Downtown Victoria North Manchester.

RIBA Stage 4 Planning Adjustments
12882-AEW-XX-XX-PP-A-0017

BS / BR 09/02/24
P01

Introduction.

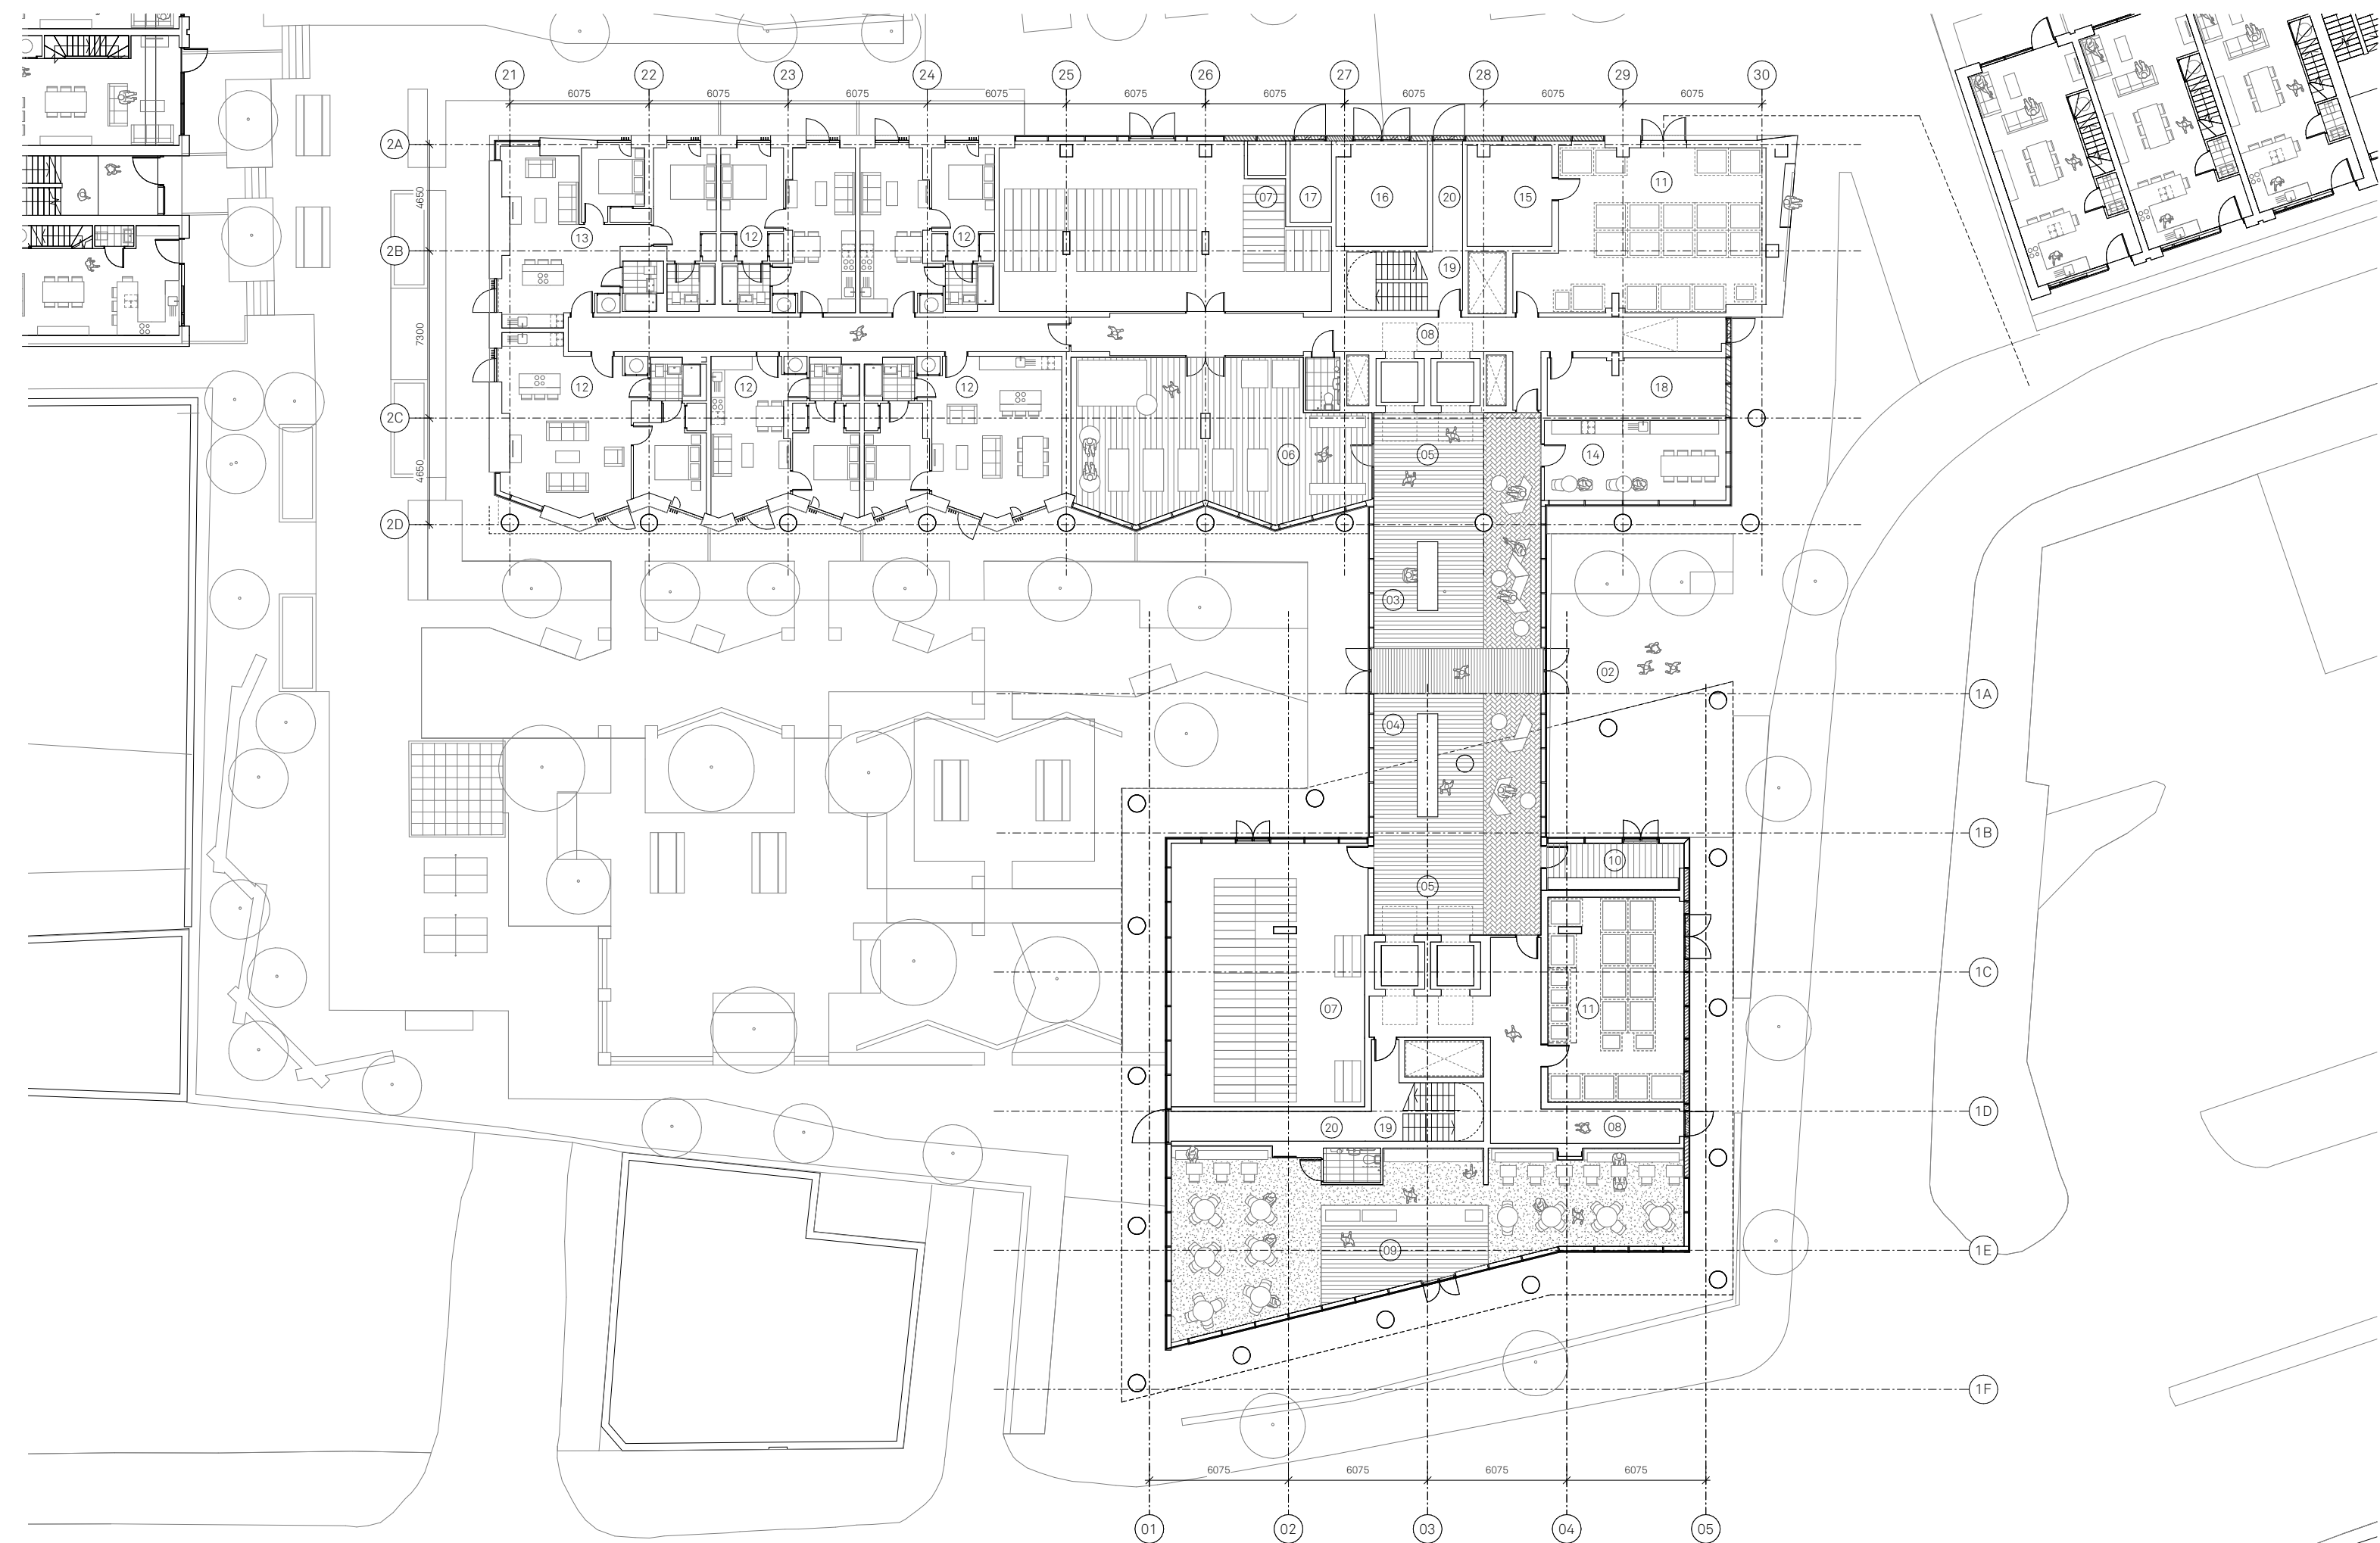
H Detailed MEP input highlighted the requirement for mechanical car park ventilation which was not proposed in the approved scheme.

J Reconfiguration of ground floor layout to suit developed structural design. External doors repositioned to suit

K Reconfiguration of ground floor elements to suit technical requirements of basement ventilation and substation

L Sliding doors introduced to main building entrance

M Minor external wall adjustment due to clash with column

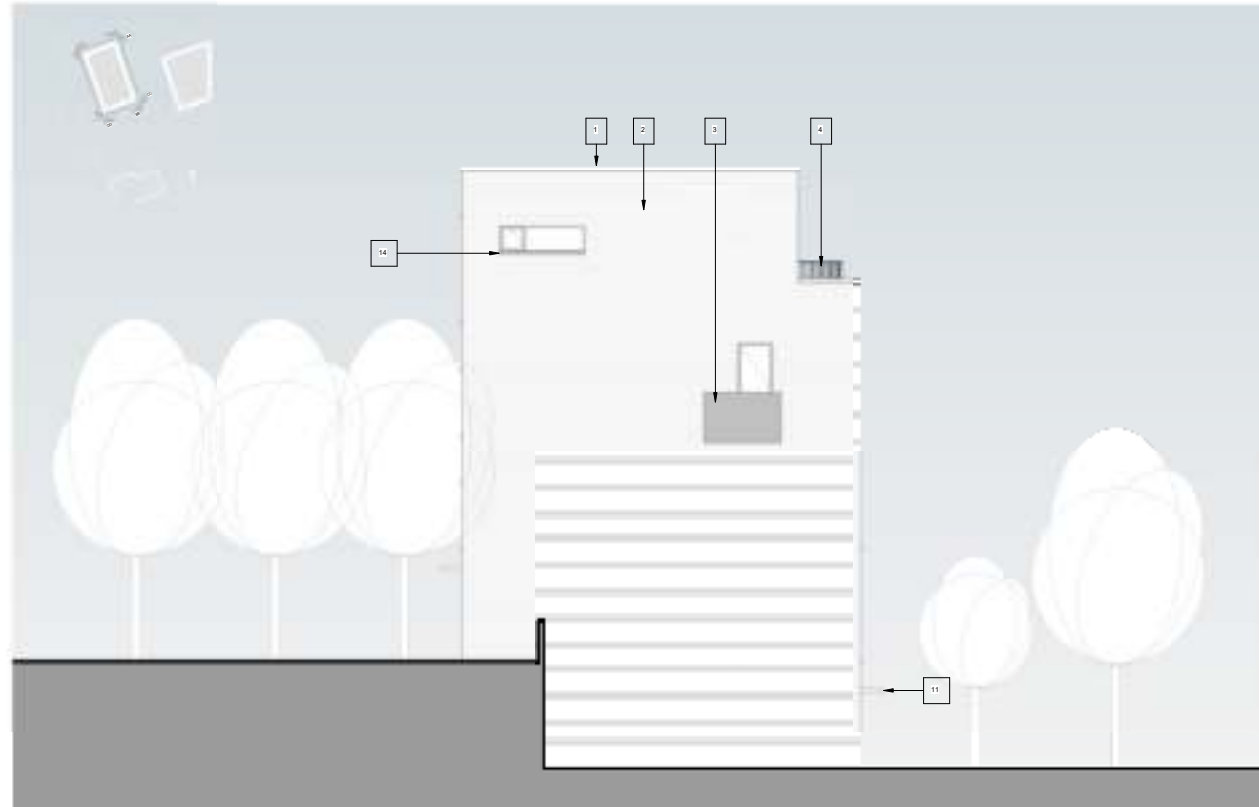
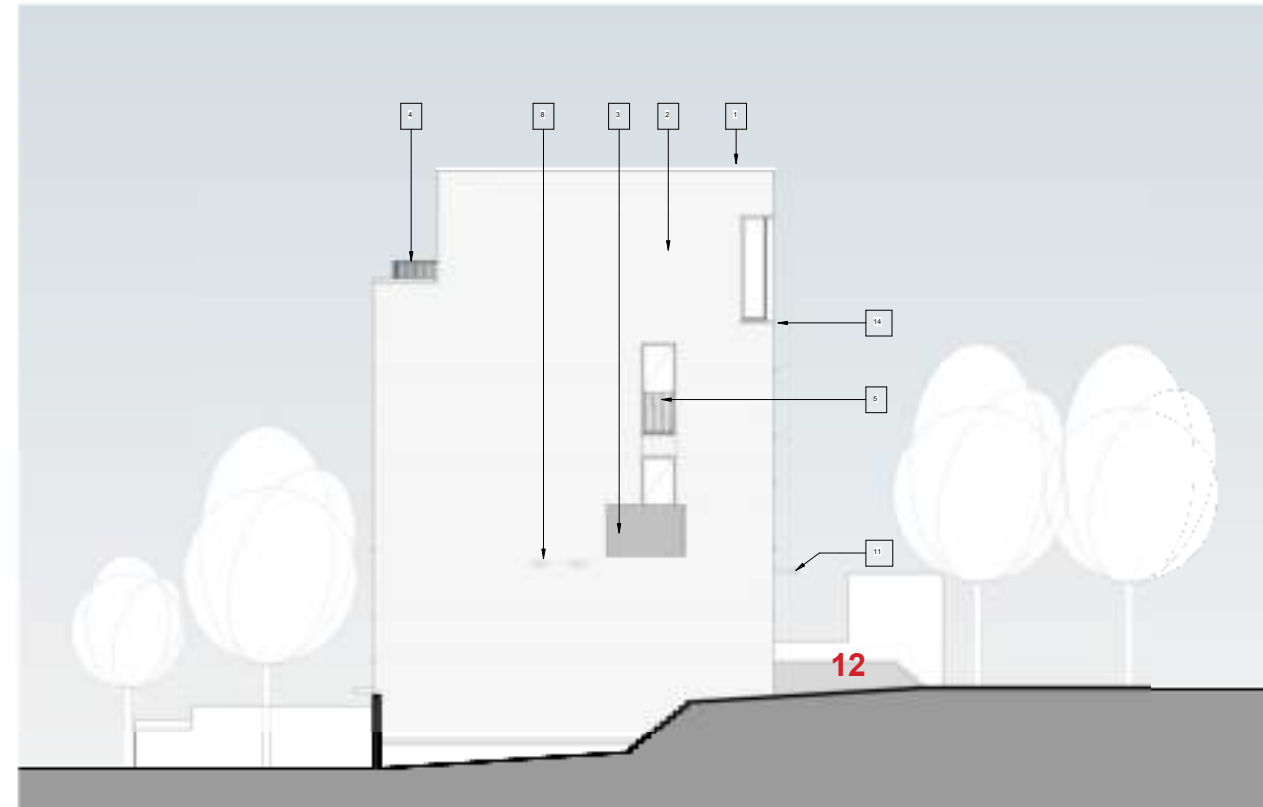
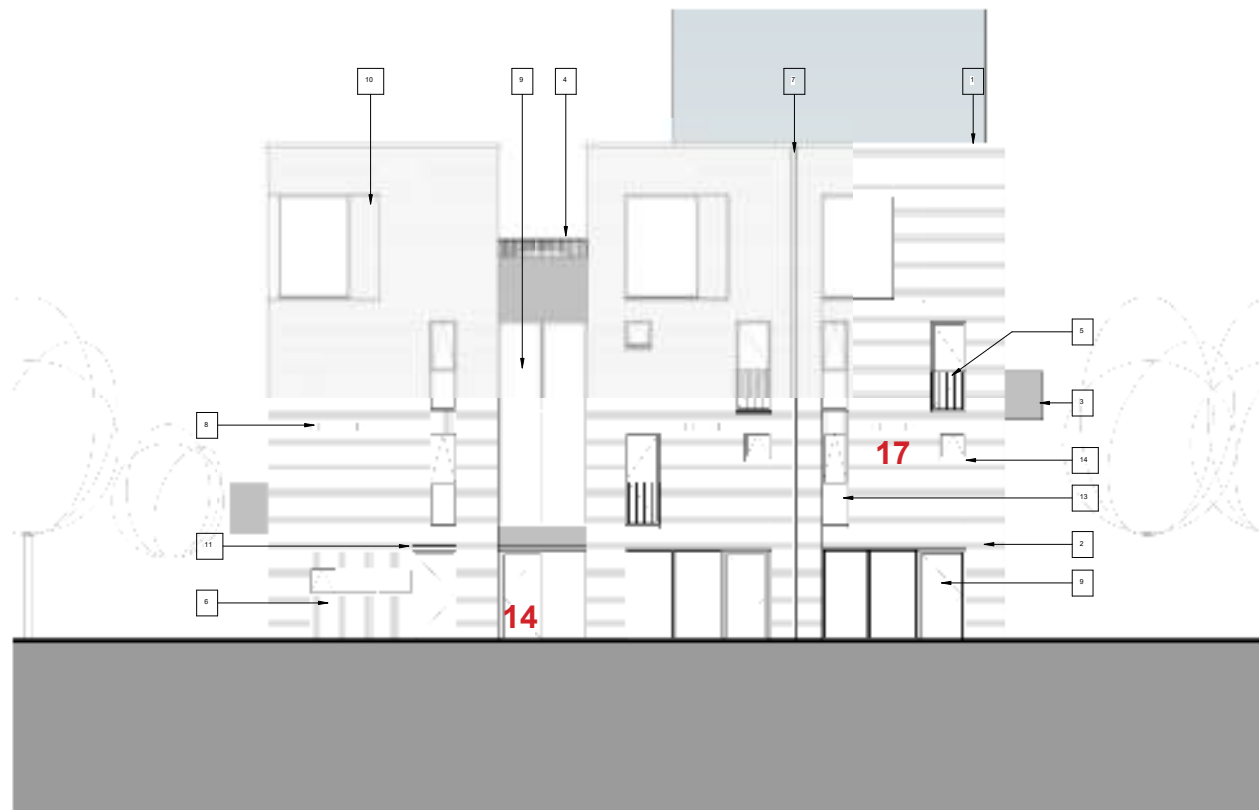
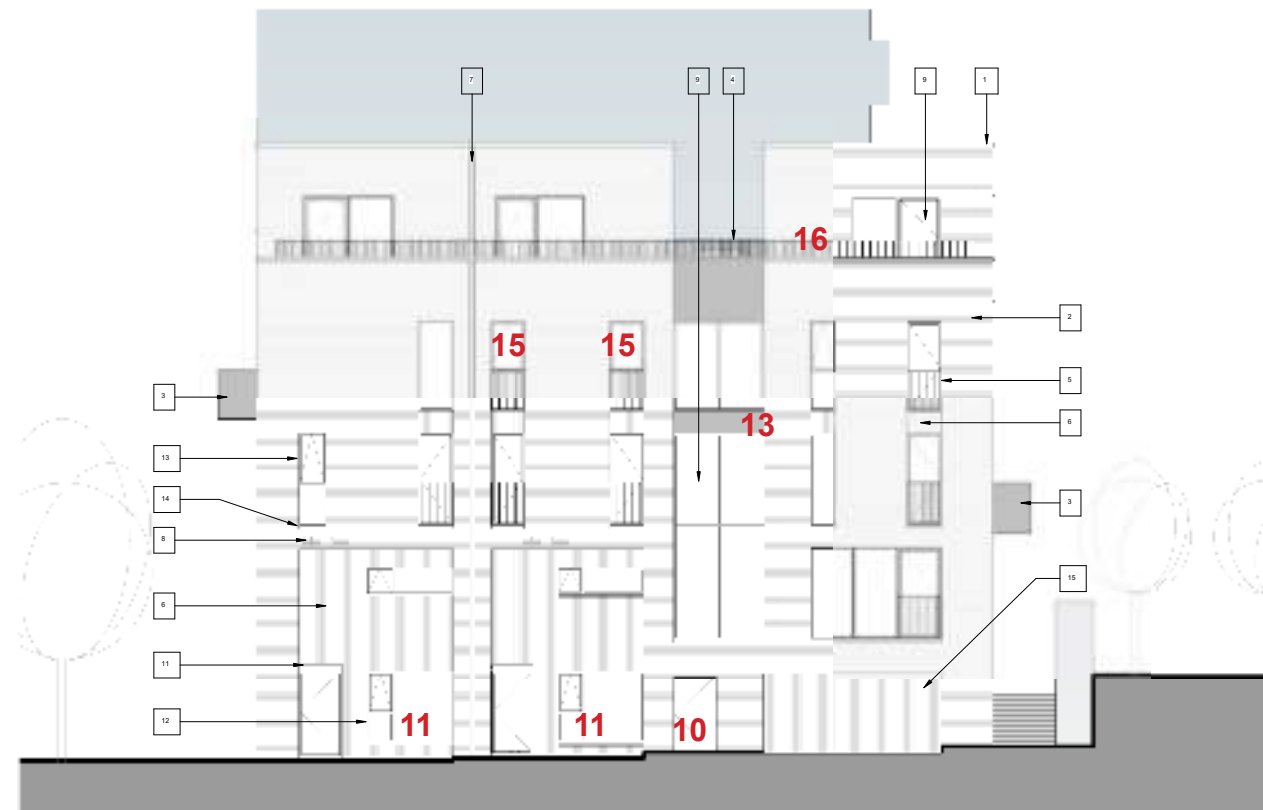
10. Additional pedestrian door added to basement car park entrance in compliance with progressed fire strategy.

11 Garages reconfigured to create live / work space.

12 Levels represented on the elevations do not reflect the planning approved landscape design.

13 Spandrel panel included within curtain wall to provide fire separation - matching reasons of item 2 on Block 1 & 2

14 Building entrance recess reduced by 225mm to enable stair and service riser to function.

15 Areas that were previously external are converted to internal space follow development of SAP assessment, thermal strategy, insufficient floor zones to accommodate insulation / cold

16 Additional edge protection provided due to insufficient height of parapet. Proposed metal railings match other balustrade proposals

17 Airbrick introduced to match Block 1 & 2 to suit ventilation requirements

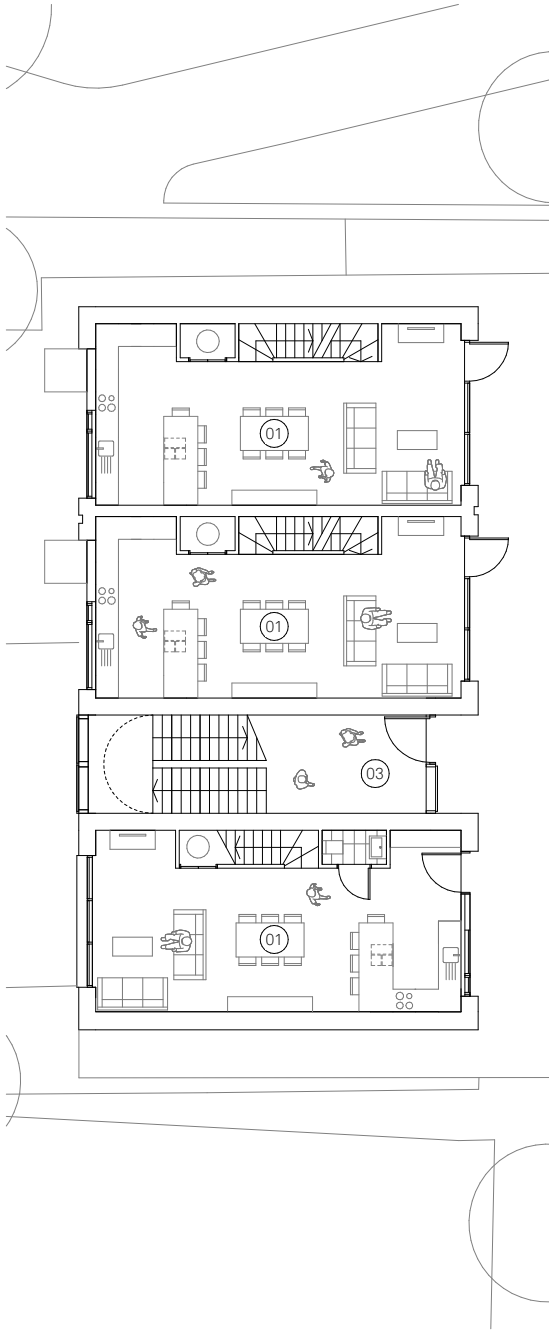
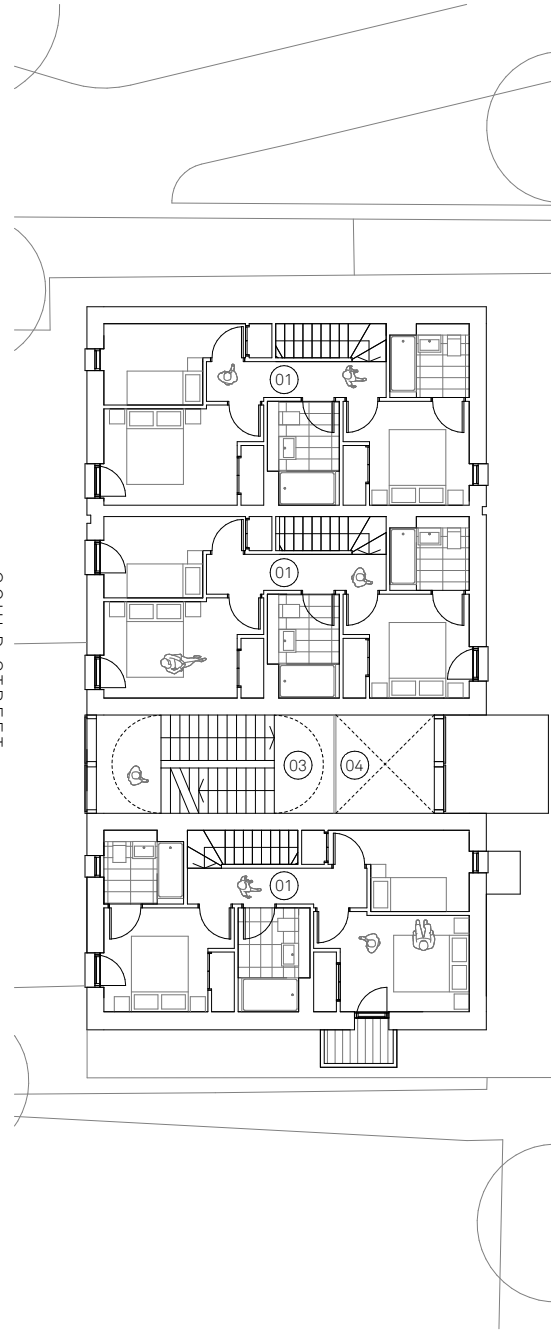
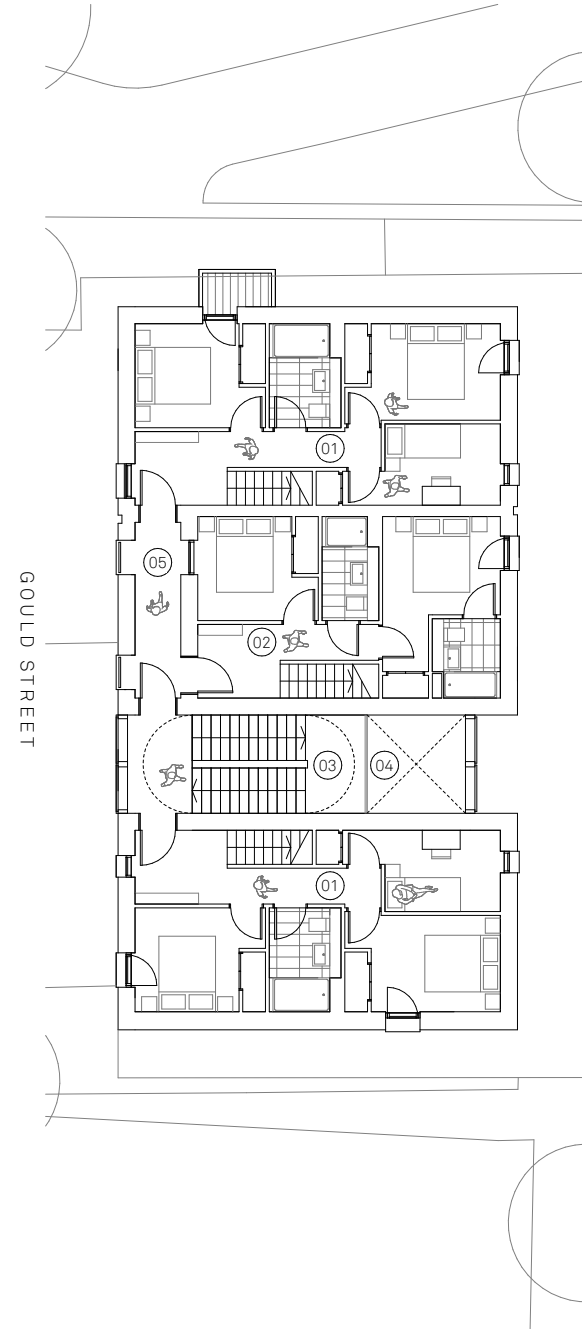
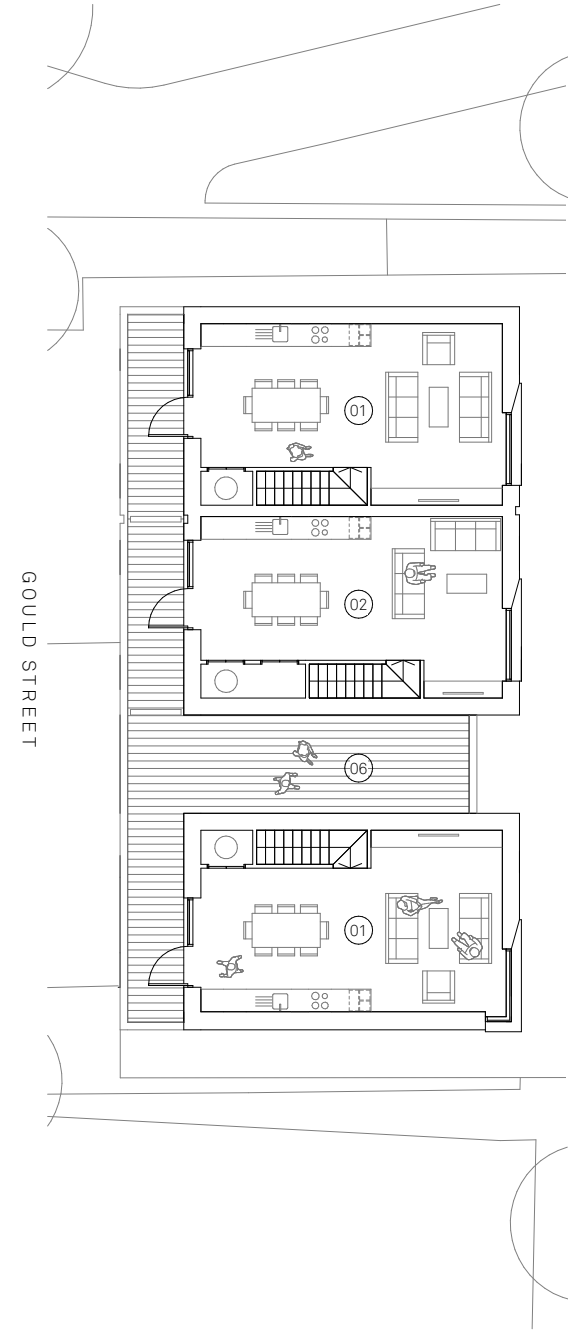
P. Additional pedestrian door added to basement car park entrance in compliance with progressed fire strategy.

Q Garages reconfigured to create live / work space due to insufficient width in plan following development of structural and thermal requirements

R Levels represented on the plans do not reflect the planning approved landscape design.

S Central stair re-configured to allow developed MEP design and cleaning / access of curtain walling

T Building entrance recess reduced by 225mm to enable stair and service riser to function.

U Areas that were previously external are converted to internal space follow development of SAP assessment, thermal strategy, insufficient floor zones to accommodate insulation / cold

V Internal elements re-configured following development of fire strategy in-conjunction with fire engineer and building control
